DECISION OF THE HEARINGS OFFICER

**CONDITIONAL USE / CLASS 3 SITE PLAN REVIEW / CLASS 2 DRIVEWAY
APPROACH PERMIT / CLASS 2 ADJUSTMENT / CLASS 1 ADJUSTMENT CASE
NO. CU-SPR-ADJ-DAP19-08**

SUMMARY: Proposed mixed-use development with three buildings, including 26 multi-family residential units, and approximately 10,242 square feet of retail floor area.

LAIKE PLAZA
DEVELOPMENT
LIBERTY RD S & HRUBETZ RD S, SALEM, OR

SHEET:
A1.01
SITE PLAN

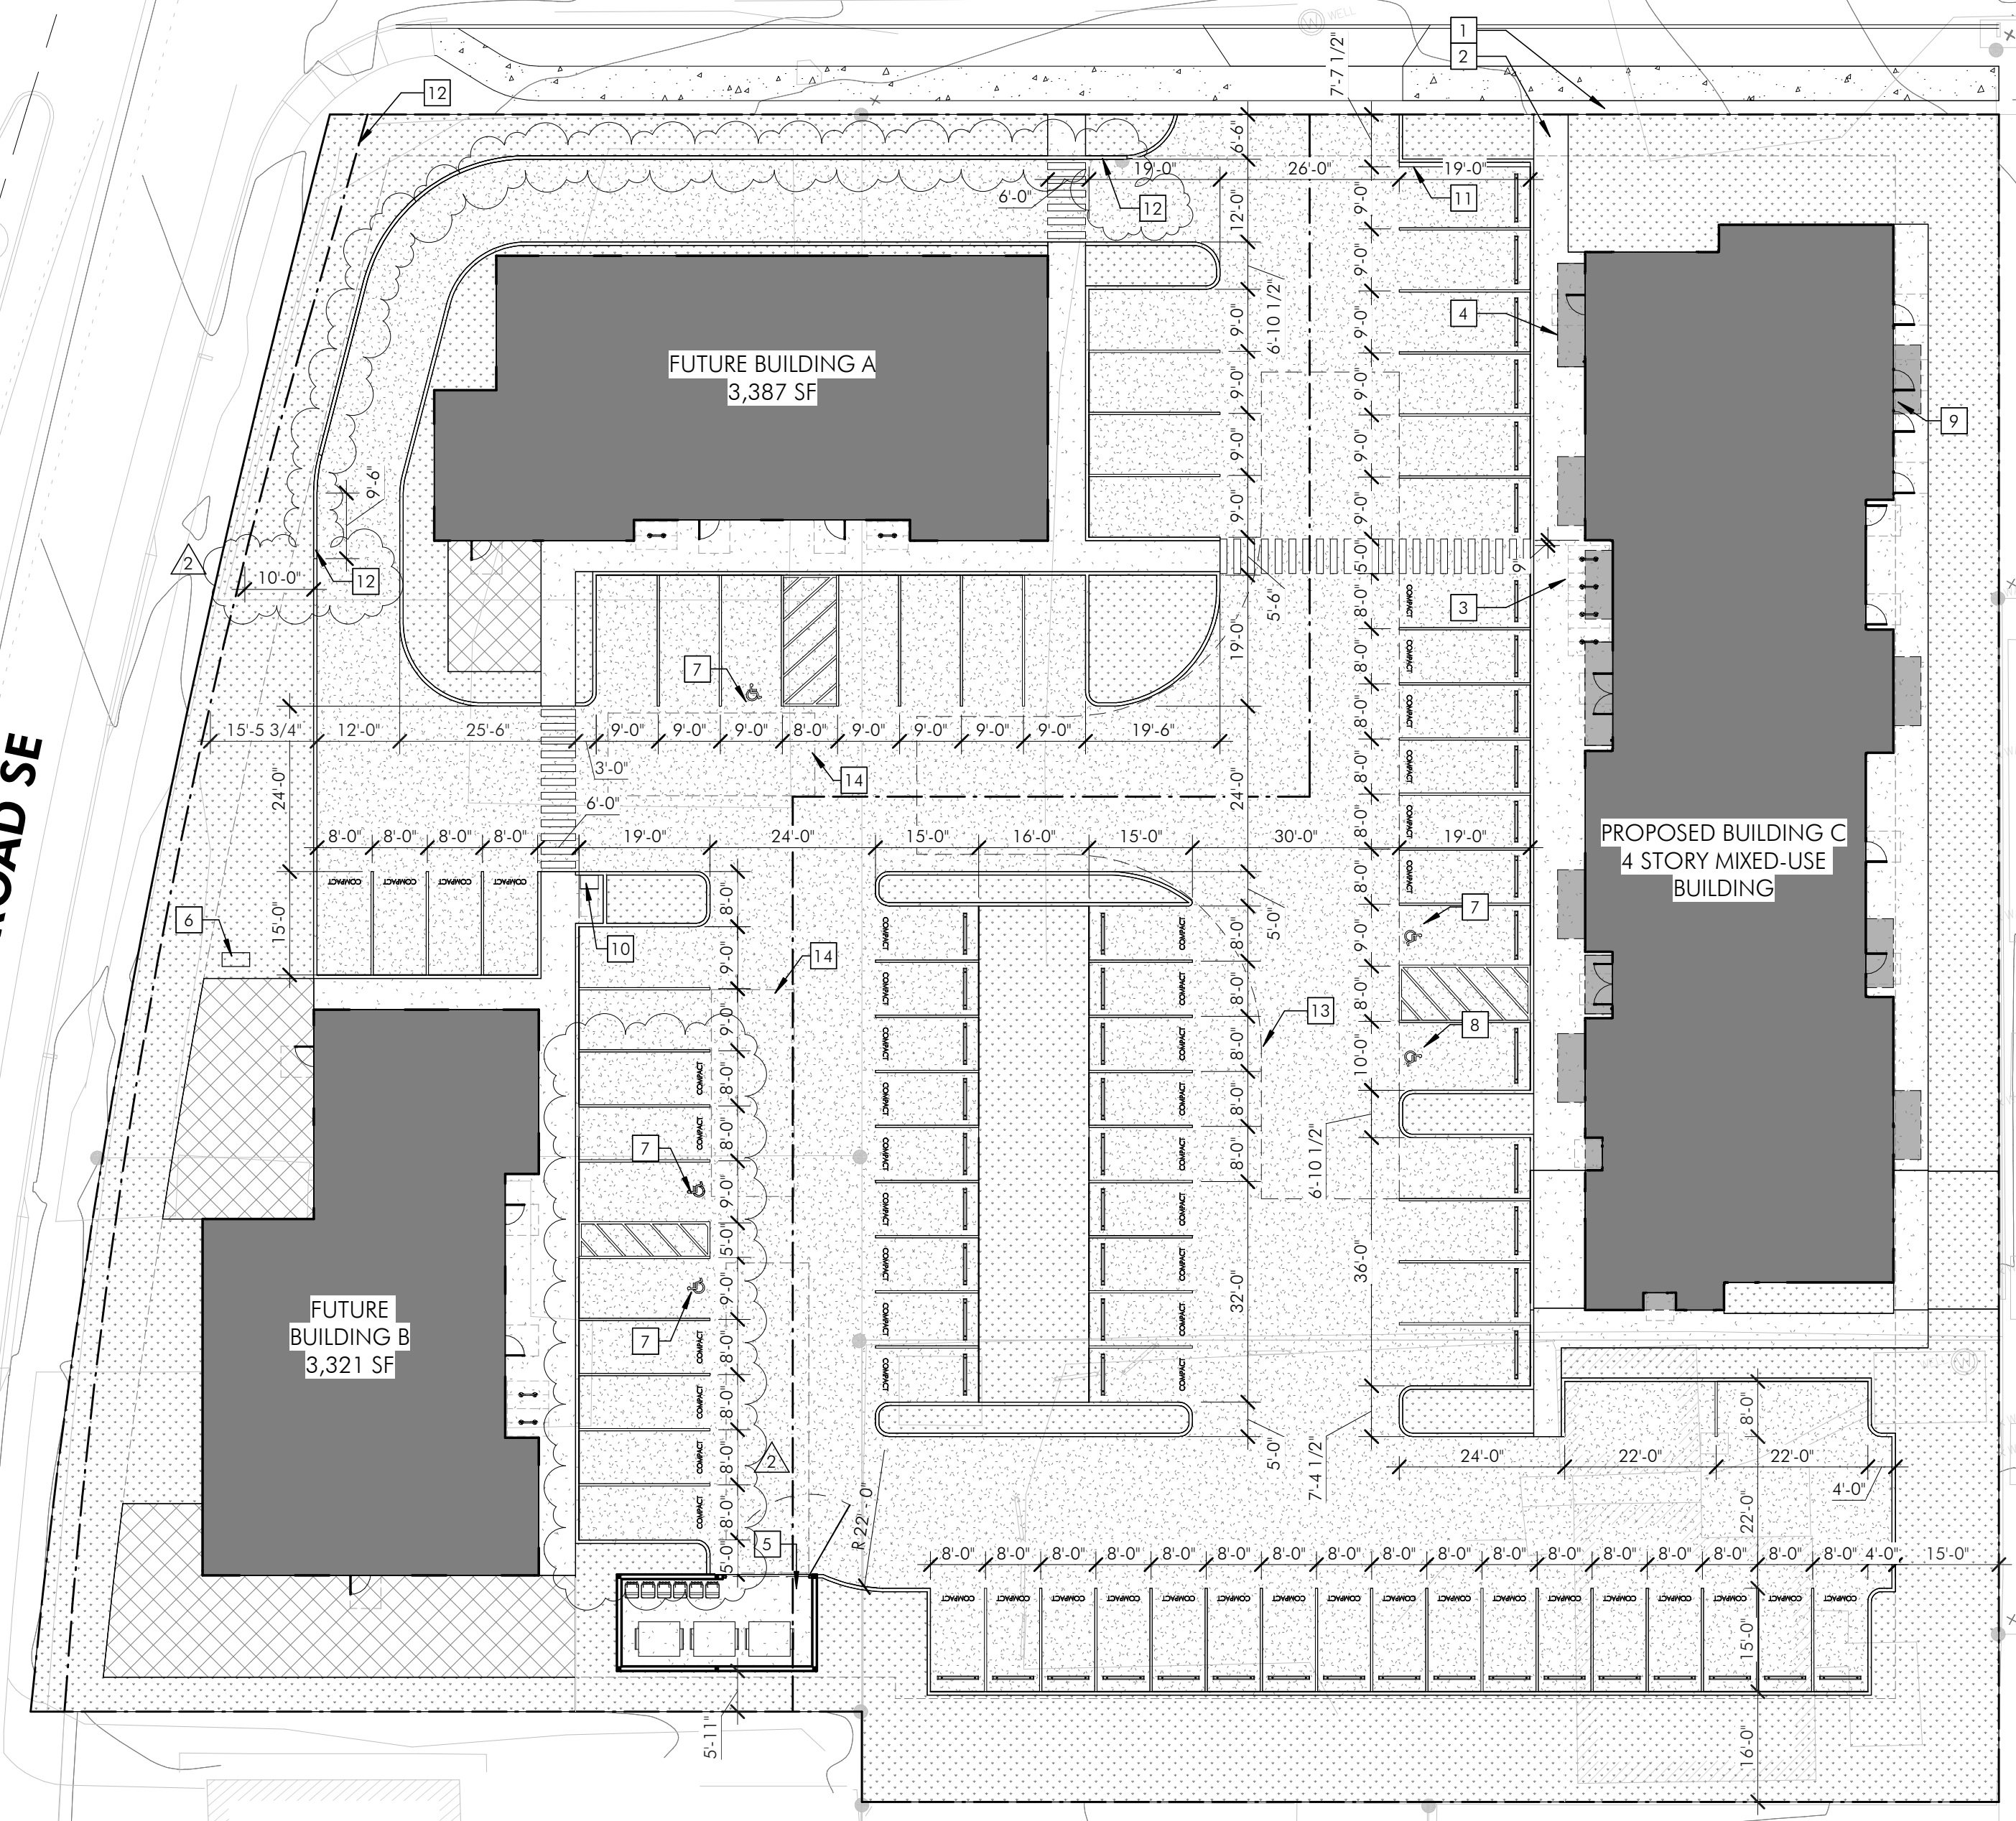
The Hearings Officer finds that the proposed site plan indicates that the enclosure walls will be cmu block. A bumper curb 12 inches inside the perimeter of the enclosure walls is required, however the curb is not indicated on the proposed plans.

The Hearings Officer finds that the proposed site plan indicates that two loading spaces will be provided for the commercial uses within a drive aisle of the proposed off-street parking area. Loading spaces are generally not allowed in the drive aisles where the loading space would conflict with the use of off-street parking spaces.

The applicant's plan shows water services connecting to an existing steel water main. Water connections shall instead be connected to the existing 12-inch ductile iron water main in Hrubetz Road SE. The existing well on the property shall be abandoned per Department of Environmental Quality standards or a reduced pressure backflow (RP) assembly must be installed pursuant to Public Works Design Standards.

Condition 5: A minimum six-foot tall sight-obscuring fence, wall, or hedge shall be provided to screen the off-street parking area from abutting residentially zoned properties to the south and east.

Condition 6: If the proposed uses for the development site will require a delivery vehicle which exceeds a maximum combined vehicle and load rating of 8,000 pounds, then the applicant shall find an alternative location for the off-street loading space meeting the requirements of SRC Chapter 806, and which does not conflict with the use of off-street parking spaces.

Condition 12: The existing well on the property shall be abandoned per Department of Environmental Quality standards or a RP assembly must be installed pursuant to Public Works Design Standards.
